**RM 220265: RESPONSE TO RFI REQUEST FOR FAR FETCHED LTD**

**CLIENT: THE WELLINGTON COMPANY**  
**ADDRESS: 189 SIMS RD, TE HORO BEACH**  
**PROJECT: RURAL COHOUSING**  
**RESOURCE CONSENT DRAWINGS**

# **Land Matters Updated Engineering Report**

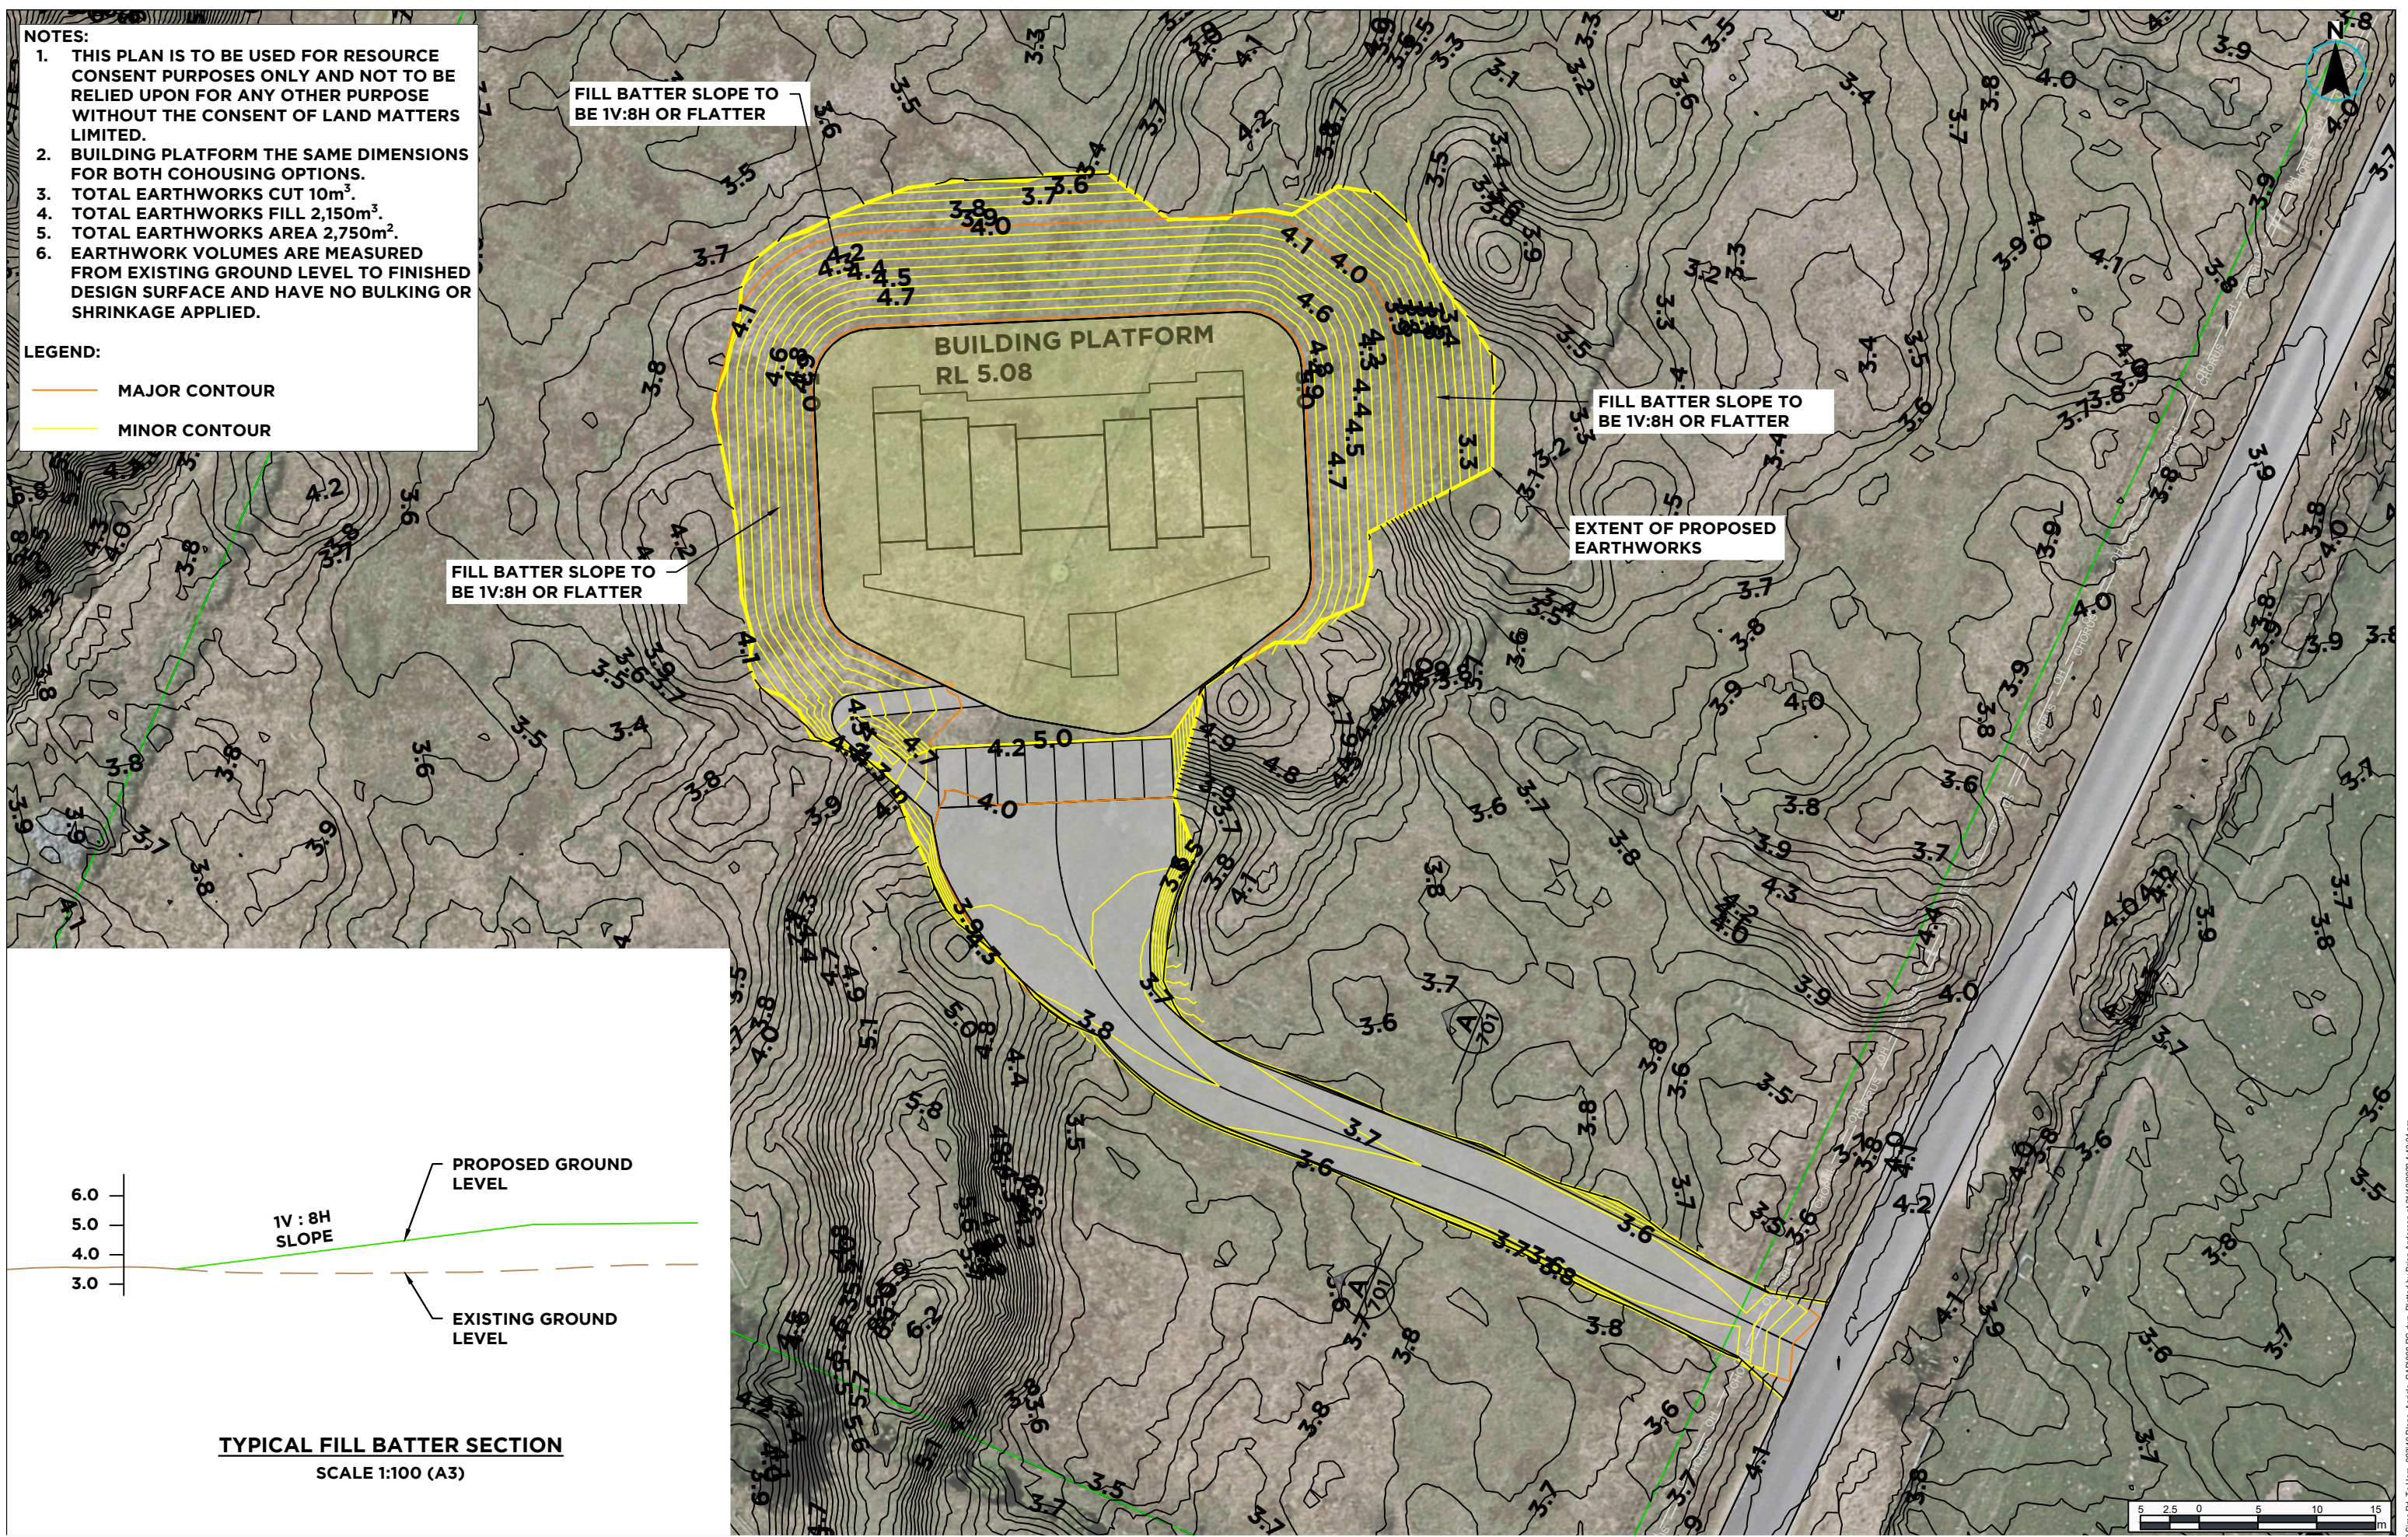
No.	Request	Response
1	<b>Please provide a revised earthworks plan for the proposed earthworks for the building platform and the driveway. The existing earthworks plan doesn't provide an indication of recommended fill batters. Please confirm the maximum fill batters proposed (height and angle of slope)</b>	Refer to updated plan set and updated plans titled, "Proposed Contour Plan" Drawing No. EW-301 Rev B; and "Depth Range Contours" Drawing No. EW-302 Rev B.

Plan Name	Plan No. & Revision	Date	Changes to Previous Plans
Proposed Contour Plan	EW-301 Rev b	21/12/22	Shows fill batter slopes
Depth Range Contours	EW-302 Rev B	21/12/22	Details cut and fill for driveway
Driveway Layout	RO-700 Rev B	21/12/22	Details vehicle entrance formation
Site Investigation Plan	GA-210 Rev A	21/12/22	Shows site investigation locations for s/w
Landscaping Plans		21/12/22	As specified
Updated Engineering Report	Revision 2	Nov 2022	Updated across entire report; includes stormwater calculations for the site. <b>Refer Appendix 2.</b>
Moller Visibility Assessment for Option B			<b>Refer Appendix 3</b>
Copy of GWRC resource consent WGN 130141			<b>Refer Appendix 4</b>

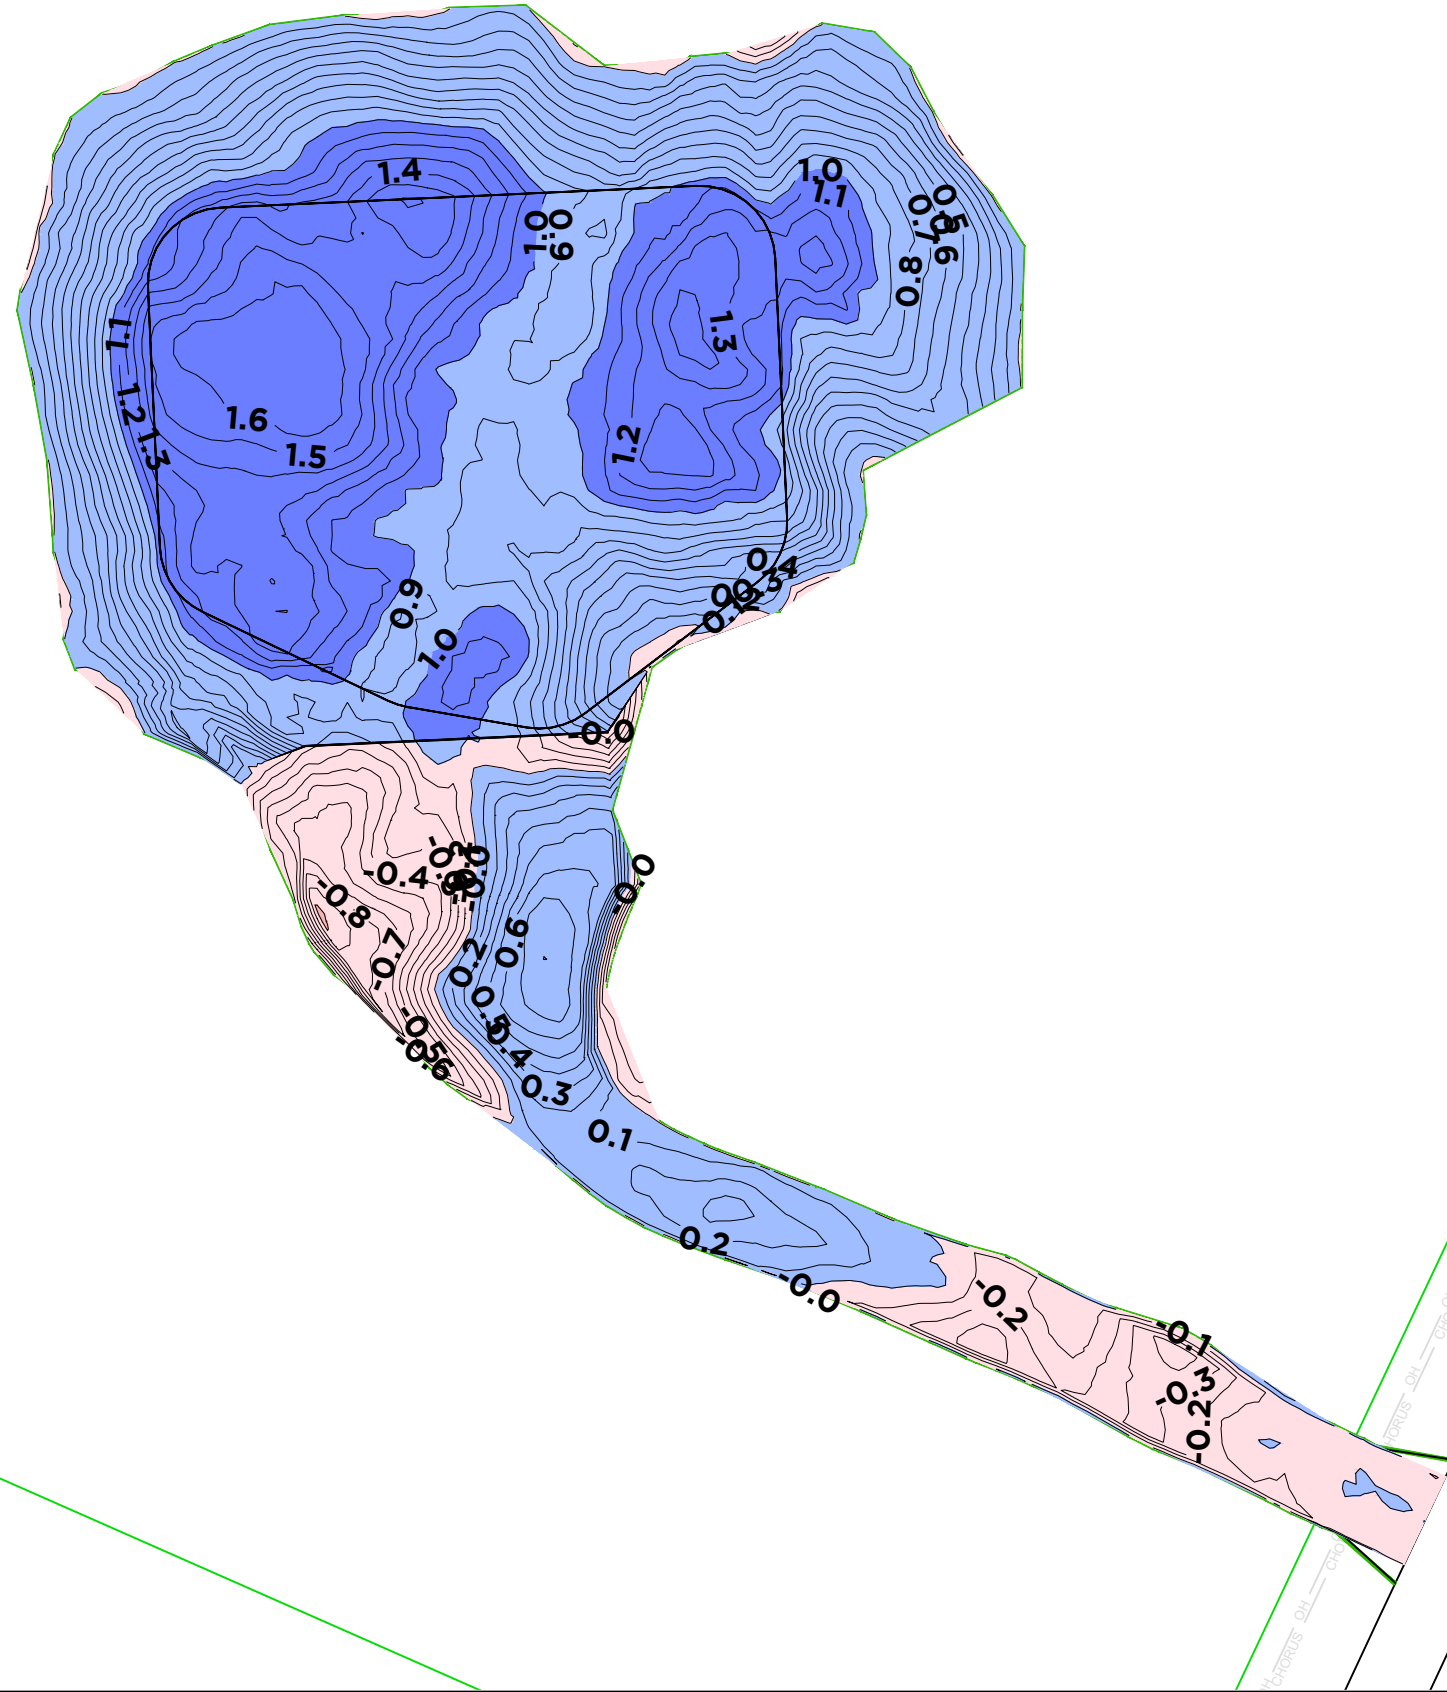
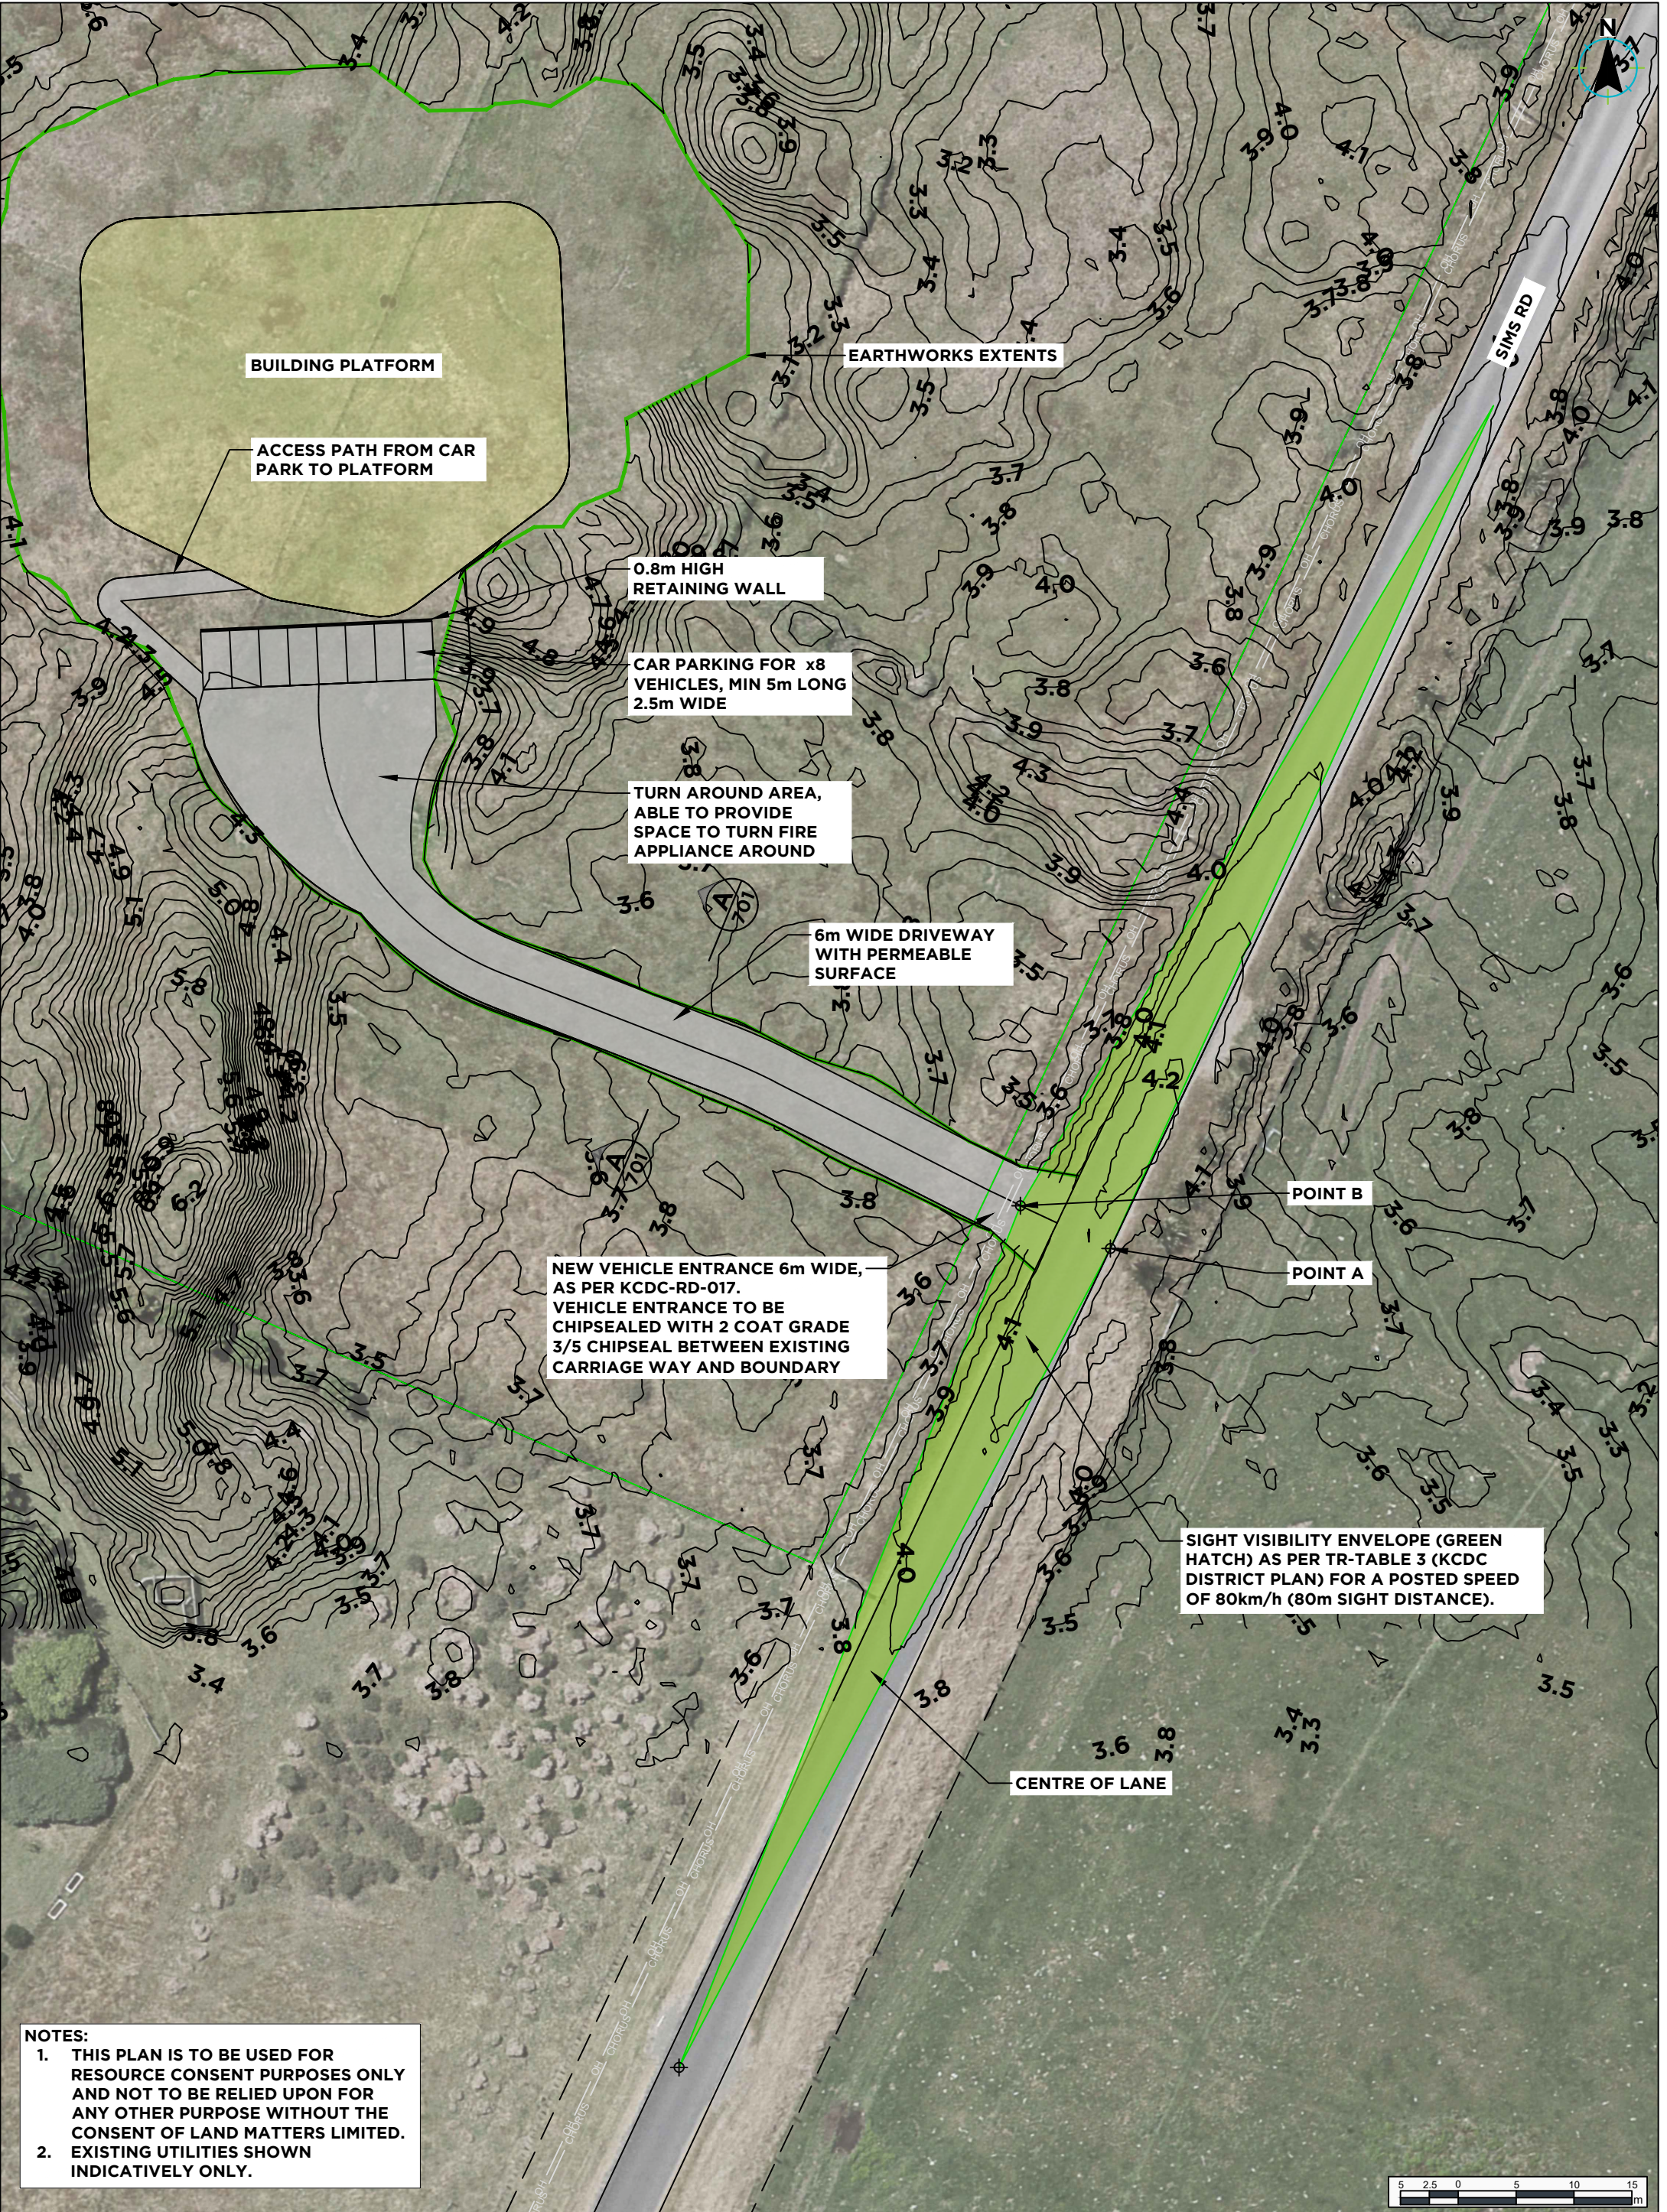
<p>2.</p>	<p>Please ensure the revised earthworks plan includes the driveway. While it is noted that the driveway could be constructed as a permitted activity, this area does need to be depicted on the plans as it forms part of the proposal. Confirmation is required that the proposed access can be built to be flood free.</p>	<p>The rules in chapter NH-FLOOD of the ODP sets out the minimum requirements for activities in the flood hazard areas identified in the District Plan and in respect of the ponding hazard area only controls the following activities:</p> <ul style="list-style-type: none"> <li>• The building floor level of any new or relocated building must be constructed above the 1% AEP event level; and</li> <li>• Any earthworks exceeding 20m<sup>2</sup> or altering the ground level by more than 1m</li> </ul> <p>As required by the District Plan, we are creating a flood free building platform. GWRC have identified that ponding waters through this area in a 1% AEP event are RL 5.3m amsl.</p> <p>There are no controls in the ODP in respect of ponding hazards requiring private accesses to be ‘flood free’ as stated in this RFI. Sims Road will also be inundated in a 1% flood event to the same depth that the private access will be with ponding waters. It is considered the safest response for occupants during a significant flood event is to stay where they are until the flood waters have receded. This was also the advice of emergency services during the last flood event that affected Te Horo Beach township.</p> <p>The provisions in INF-MENU chapter of the ODP specifies policies and rules in respect of managing effects on <i>network infrastructure</i>. Rule INF-MENU-R27 of the Operative District Plan requires that “all development must be undertaken in accordance with Council’s SDPR, 2012 document. We have noted in our AEE that the proposed development complies with the SDPR and we maintain that position in respect of this matter. The SDPR document (at pp 19 &amp; 55, SDPR) notes that,</p> <ul style="list-style-type: none"> <li>• <i>“Areas of private property may be able to become inundated (usually not exceeding 300mm) provided they are not used as building sites, and roads may be inundated up to 200mm, in the 1% AEP storm event. A distinction is made between inundation by ponding and inundation where flood waters are likely to generate scour velocities and consequent erosion.”</i></li> </ul> <p>Council’s SDPR only requires building sites and ‘roads’ to be flood free. Private accesses which are not roads are not required to be flood free. While there is a preference for flood free accesses (or accesses that are not inundated by more than 200mm), there is no logic to applying that reasoning to this site when Sims Road may be inundated by up to 1.7m in a 1% AEP event. It is important to note that the SDPR also makes a distinction between a site that is subject to ponding and one that is at risk from flowing waters.</p>
